STATE OF NORTH CAROLINA
DEPARTMENT OF TRANSPORTATION

Subject: **Information to comply with Section 401 conditions** for US 401 widening from SR 2044 (Ligon Mill Rd) to north of SR 2226 (Jonesville Rd), Wake County, Federal Aid No. STP-401(4), State Project No. 81403001, WBS 34506.1.1, Division 5, TIP R-2814 A.

Reference: Section 404 Individual Permit, issued July 14, 2009, USACE Action ID 2008-01316
Section 401 Individual Water Quality Certification, Isolated Wetlands Permit and Neuse Riparian Buffer Authorization issued June 16, 2009, NCDENR-DWQ Water Quality Certification Project No. 20090104 ver.1

Revised
 Construction
 plan
 sheet
 7/8/10

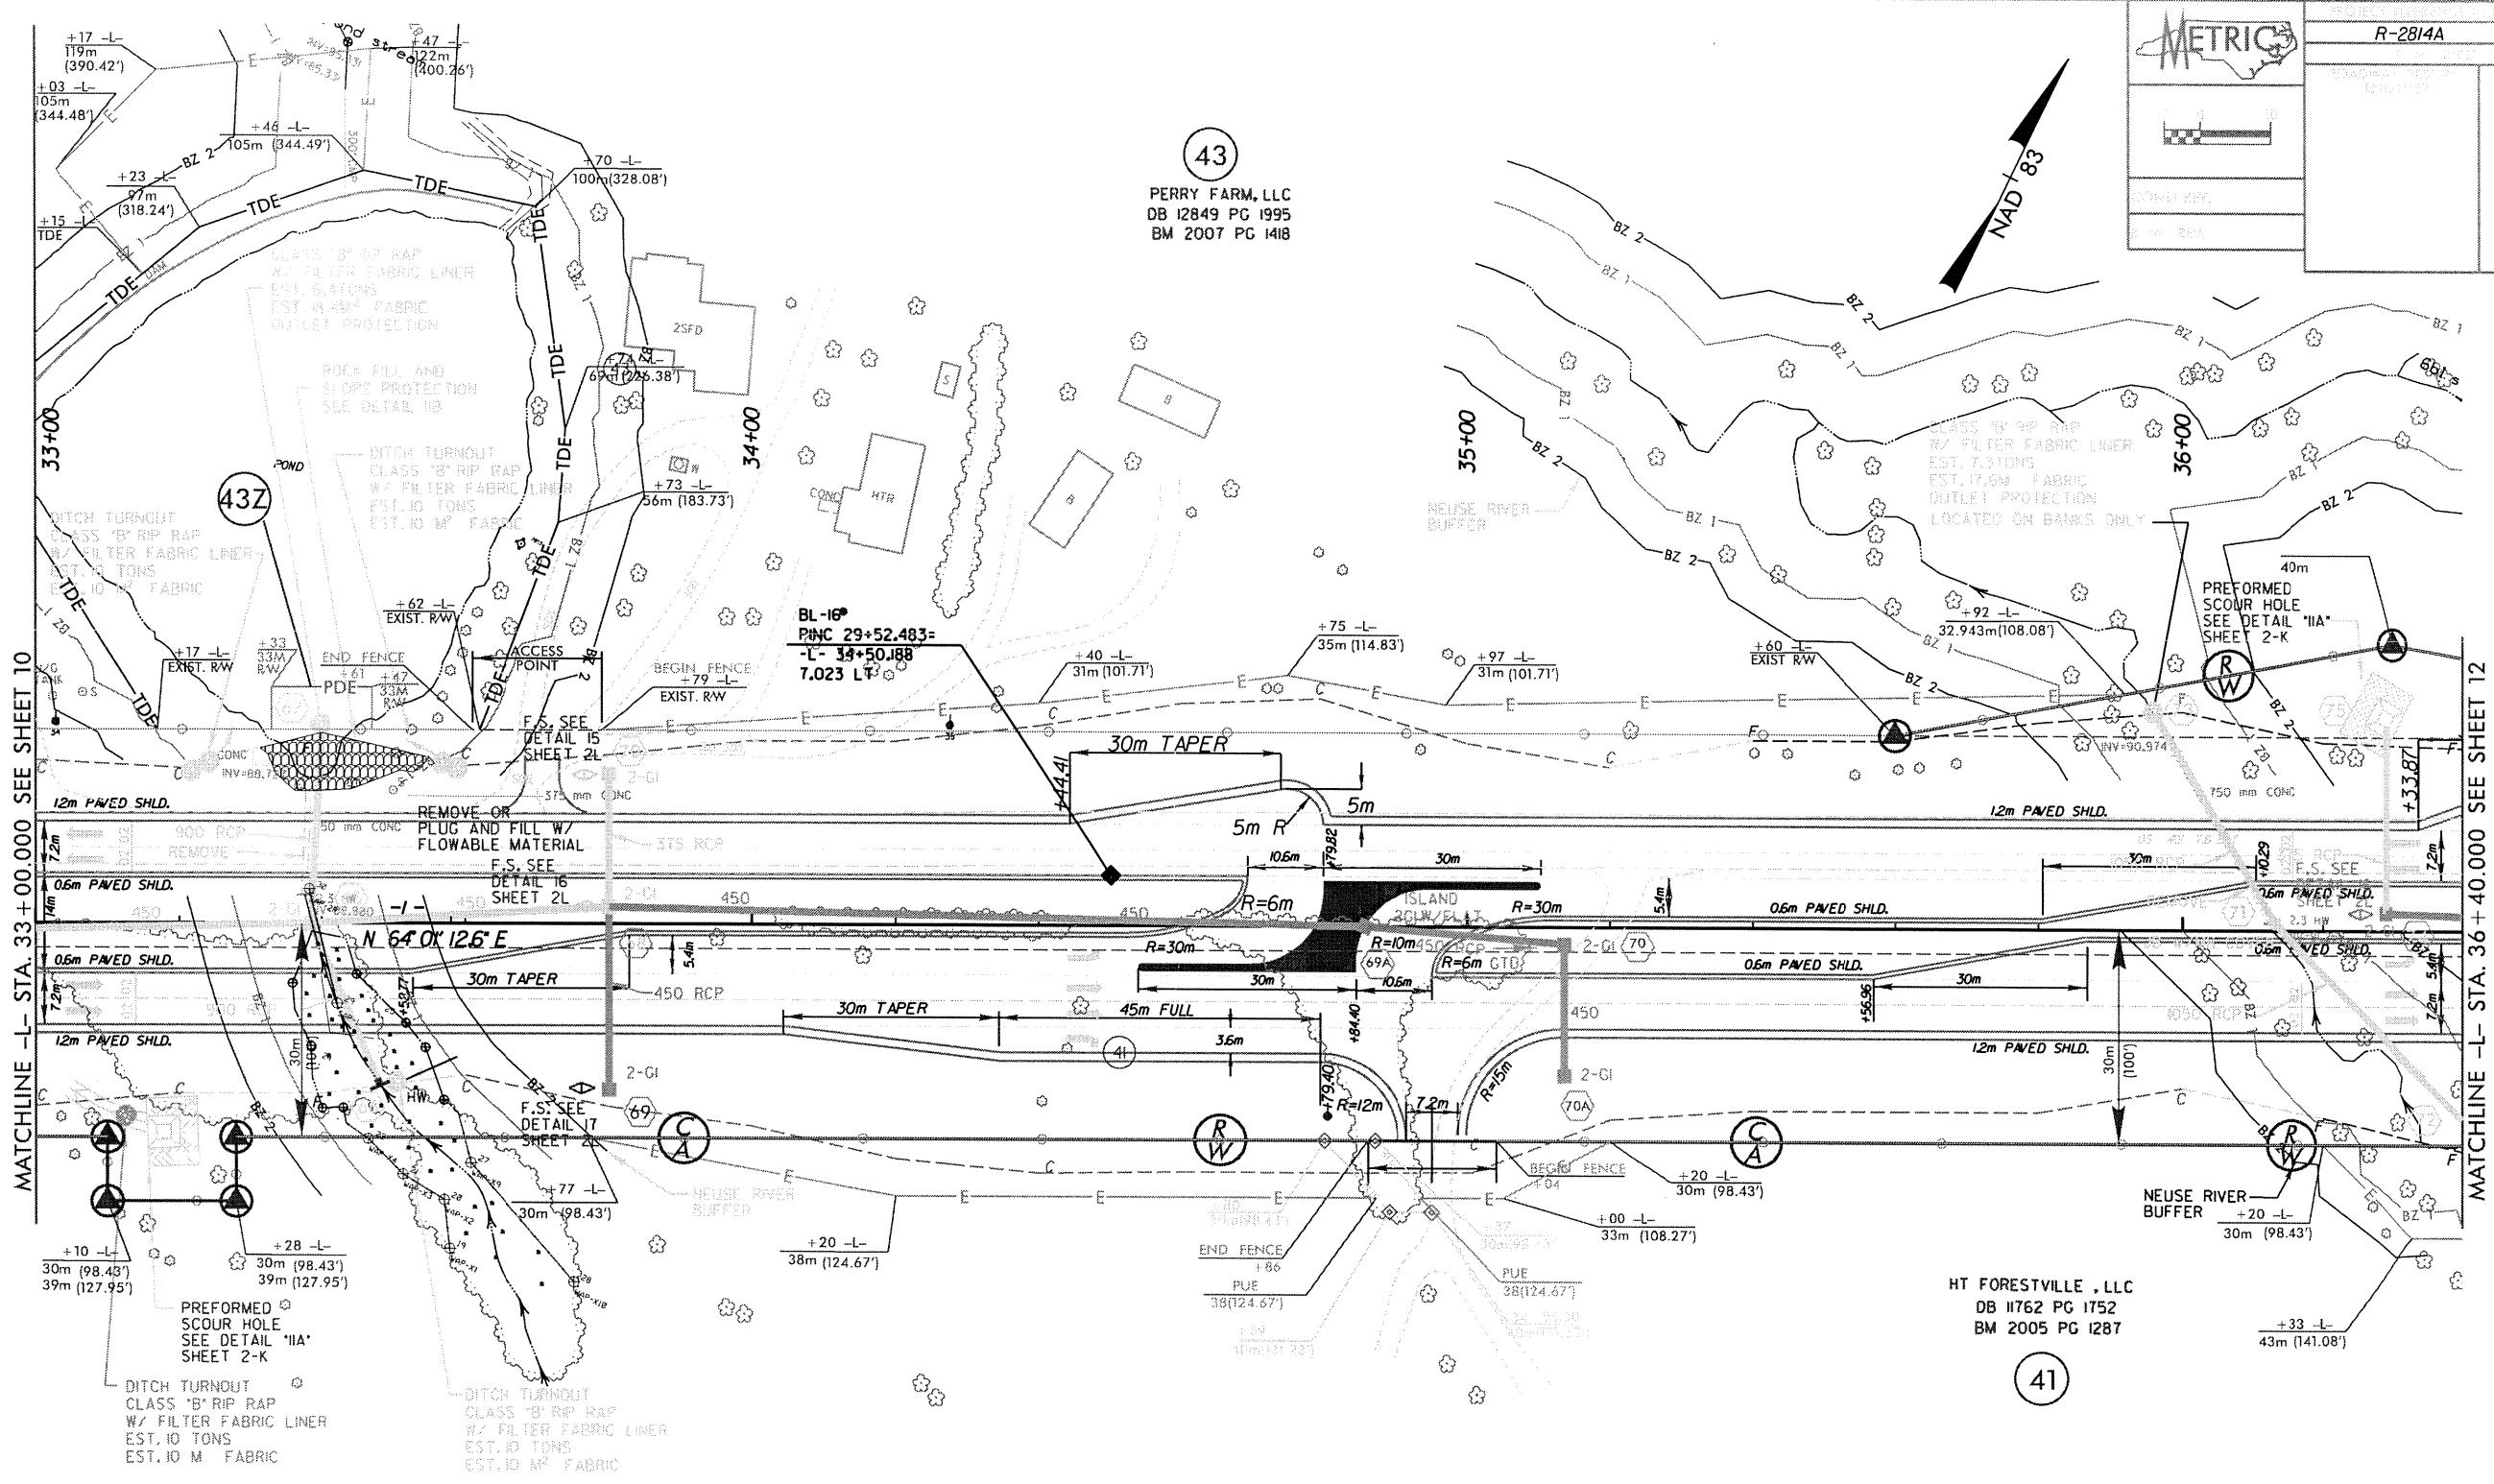
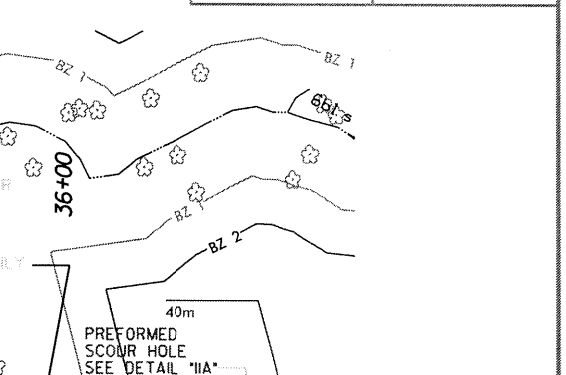
Issue: Construction plan sheet 11 and buffer permit drawing 8 depict a ditch with no liner information at the high end of a pre-formed scour hole (PFSH) located at 33+15 Rt. Stream permit drawings 12 and 13 depict rip rap in the ditch at the high end of the PFSH.

Issue: Stream permit drawings 12 and 13 depict a rip rap blob in the stream at the outlet of a 1050 mm pipe structure at 35+95 Lt. Buffer permit drawing 8 depicts no rip rap blob in the stream at the outlet of this 1050 mm pipe structure. Construction plan sheet 11 depicts a rip rap blob in the

Issue: A headwall has been designed to be installed at the inlet of a 900 mm pipe structure at Station 33+45 Rt.

Response: Revised construction plan sheet 11 and revised buffer permit drawing 8 reflect rip rap in the ditch at the high end of the PFSH as depicted on stream permit drawings 12 and 13.

Response: Revised construction plan sheets 11 and 12, revised stream permit drawings 12, 13, 14 and 15, and revised buffer permit drawings 8 and 9 reflect the revised hydro design.

Response: This construction revision has been depicted on revised construction plan 11, revised stream permit drawings 12 and 13, and revised buffer permit drawing 8.

*Revised Construction
 Plan sheet 7/8/10*

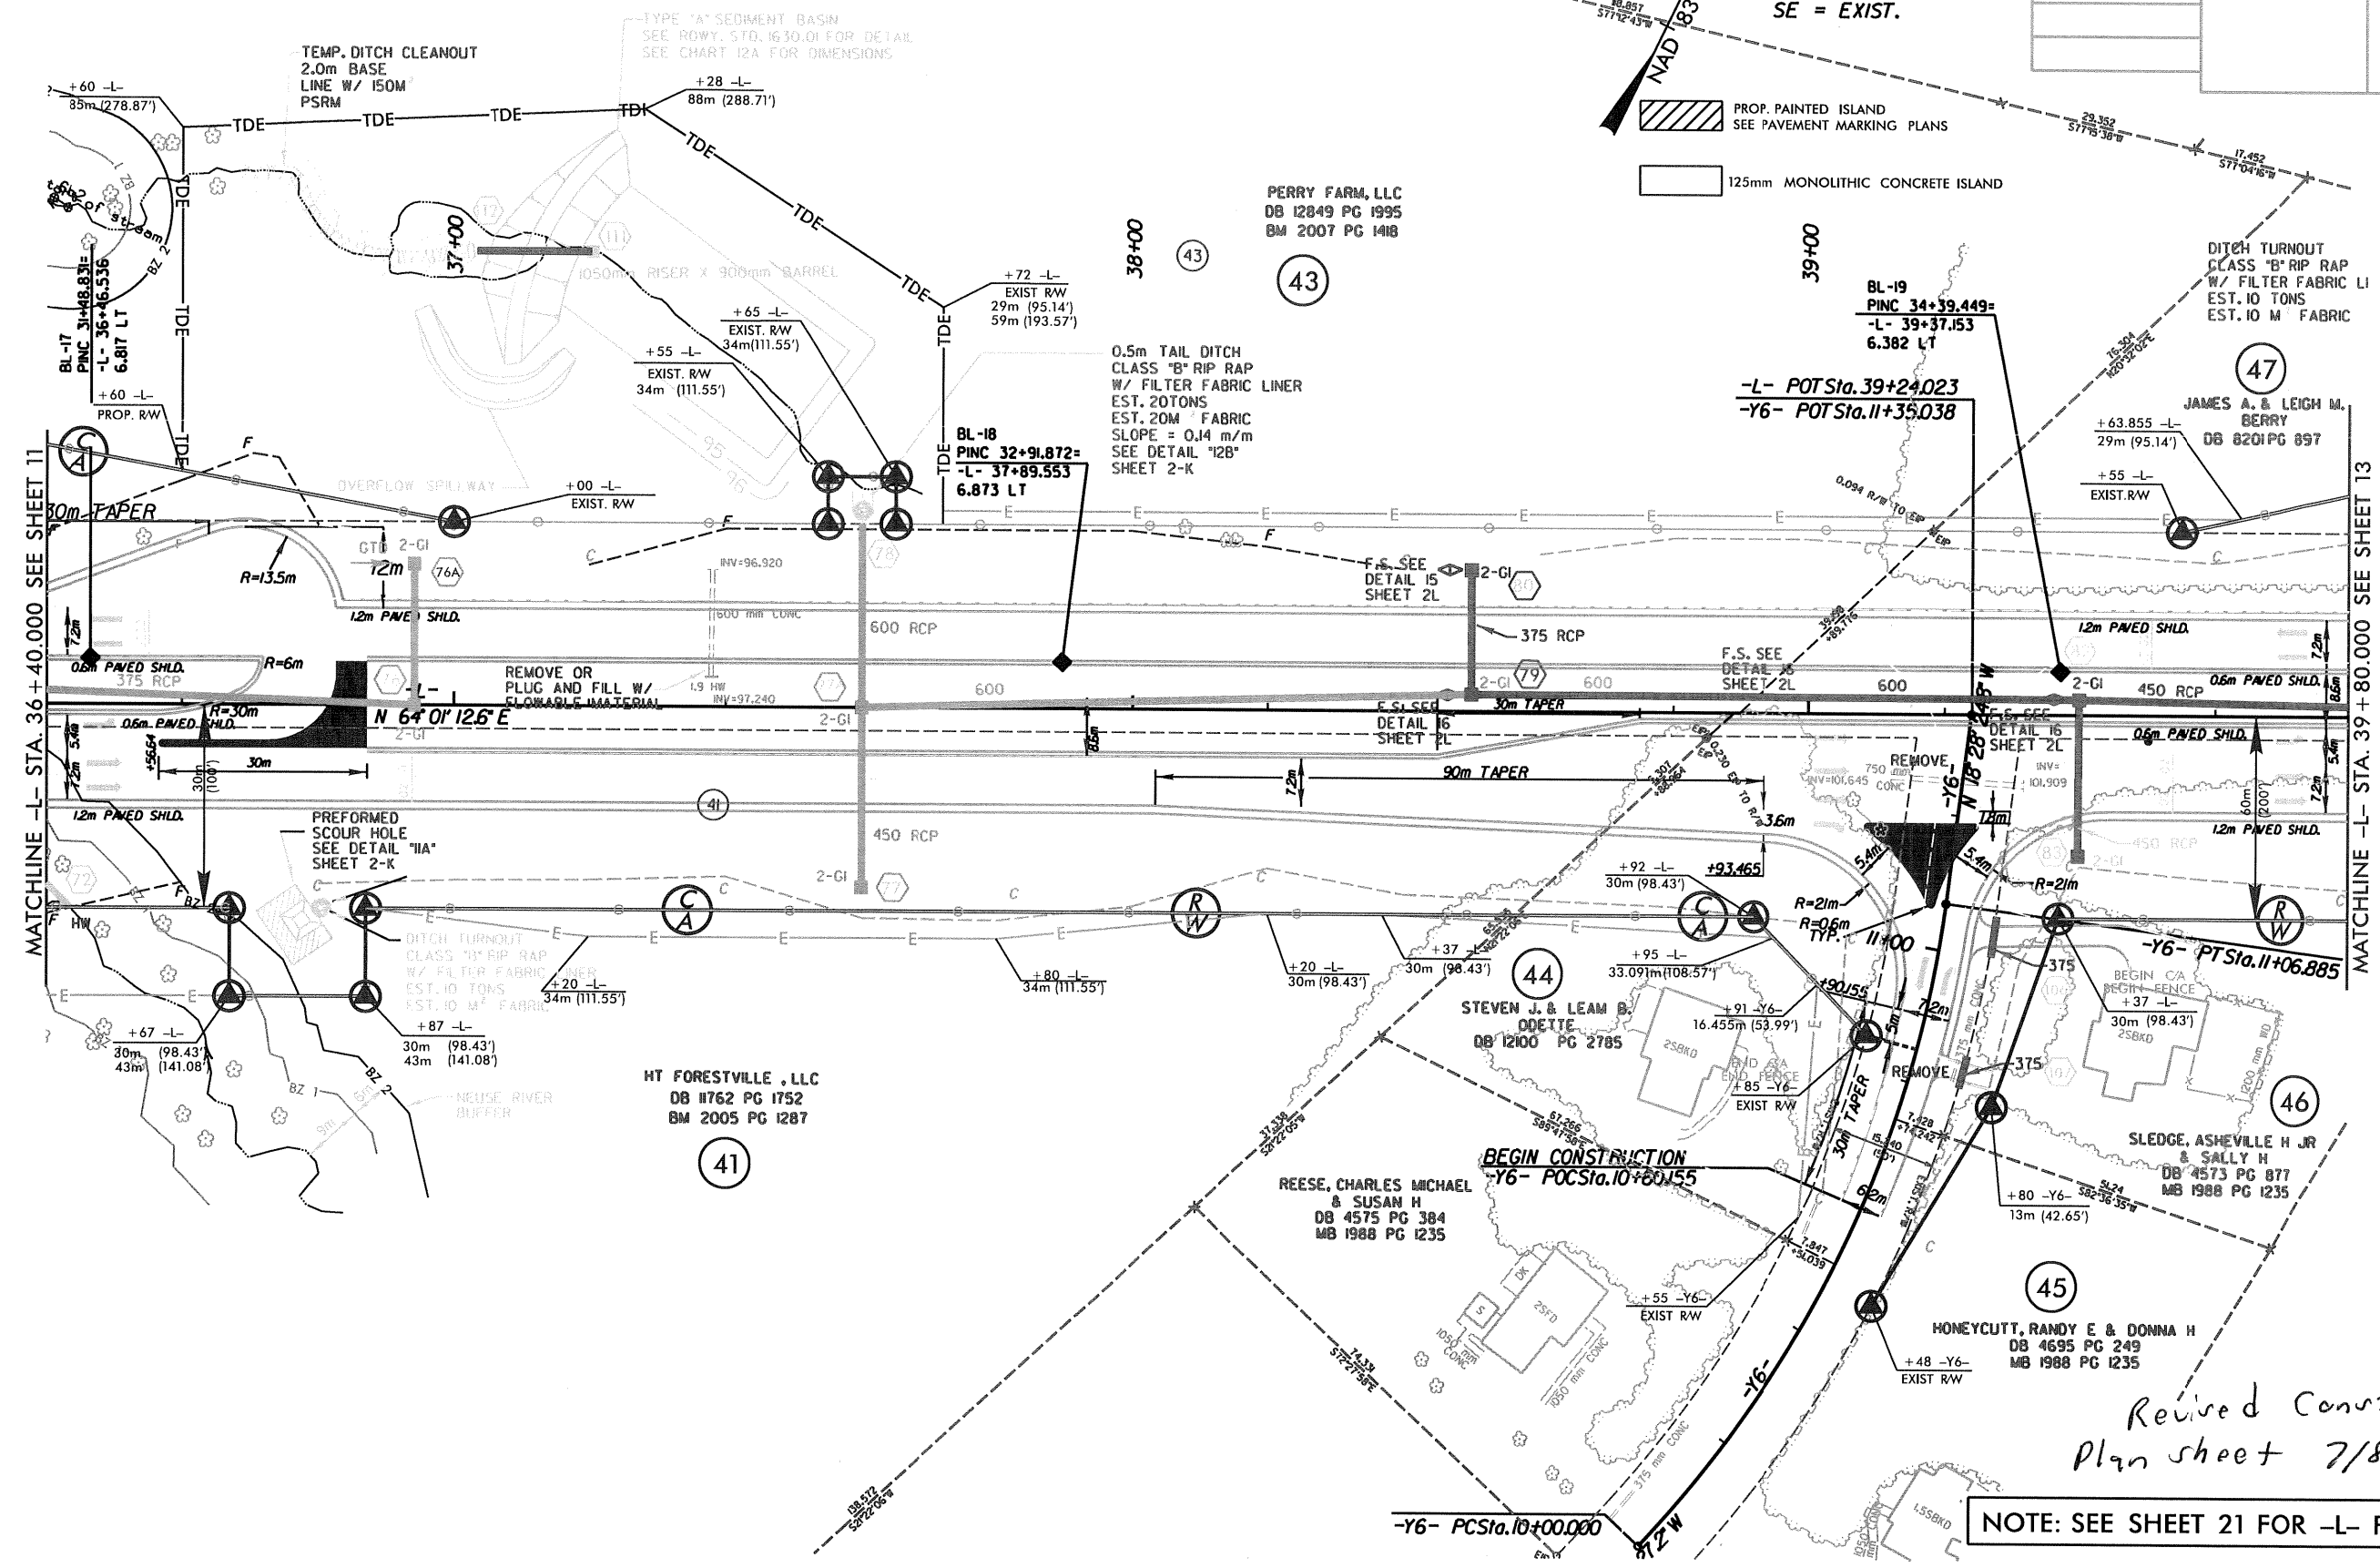
Issue: Construction plan sheet 12 depicts a ditch turnout with rip rap at the high end of a PFSH located at 36+80 Rt. Stream permit drawings 14 and 15 and buffer permit drawing 9 depict no ditch turnout with rip rap at the high end of the PFSH.

Issue: A headwall has been designed to be installed at the inlet of a 1050 mm pipe structure at Station 36+45 Rt.

Response: Revised stream permit drawings 14 and 15 and revised buffer permit drawing 9 reflect the ditch turnout with rip rap at the high end of the PFSH as depicted on construction plan sheet 12.

Response: This construction revision has been depicted on revised construction plan 12, revised stream permit drawings 14 and 15, and revised buffer permit drawing 9
